UNITED STATES MARINE CORPS
ENVIRONMENTAL MANAGEMENT DEPARTMENT
INSTALLATION RESTORATION PROGRAM
CAMP LEJEUNE, NORTH CAROLINA

COMMENTS: COMMENTS ON DRAFT INTERIM REMEDIAL

INVESTIGATION/FEASIBILITY STUDY PROJECT PLAN OP. UNIT 10
(SITE 35)

**INTERIM REMEDIAL INVESTIGATION/
FEASIBILITY STUDY PROJECT PLAN**

FIGURE 2-4
 CONCENTRATION OF TPH SOIL CONTAMINATION
 CAMP GEIGER AREA FUEL FARM
 REMEDIAL INVESTIGATION/
 FEASIBILITY STUDY CTO-0160
 ARMY CORPS BASE, CAMP LEJEUNE
 NORTH CAROLINA

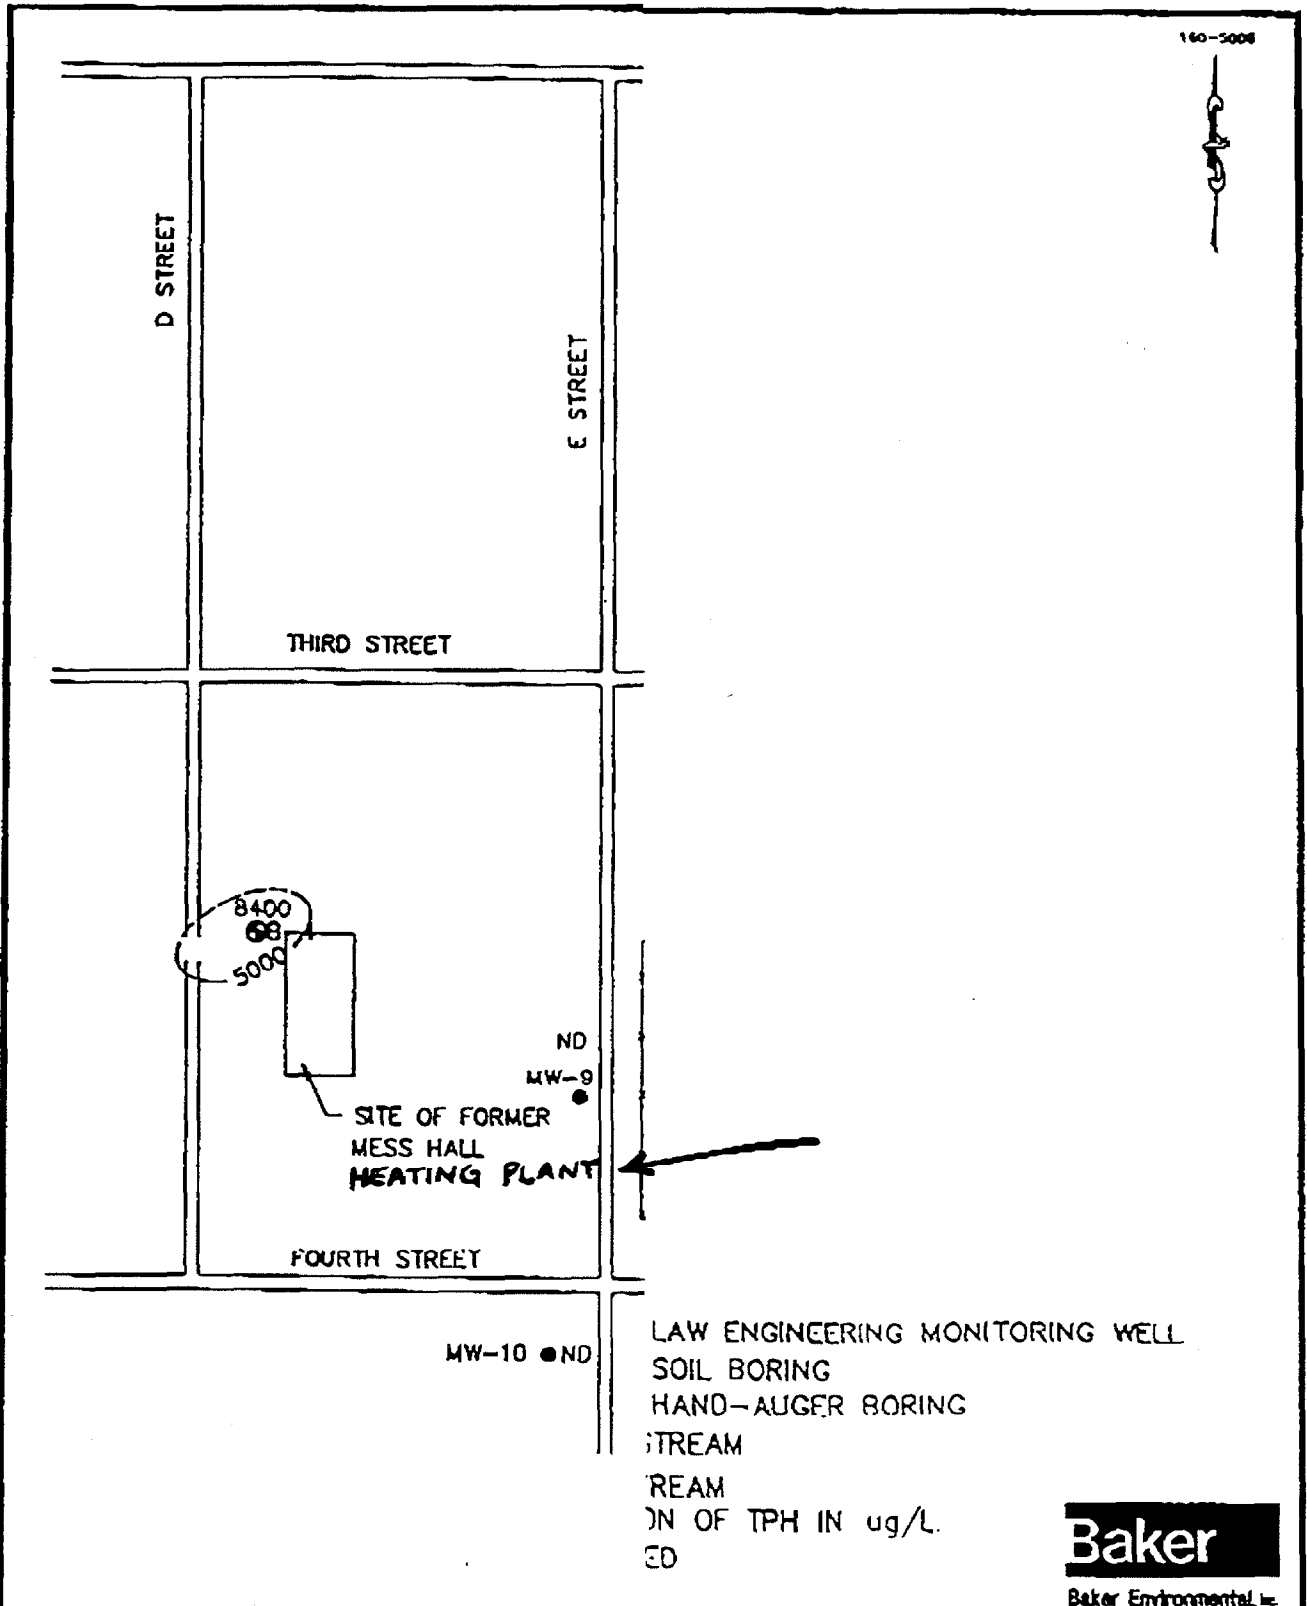
? DRIVER FOR 6-12" BGS SAMPLES
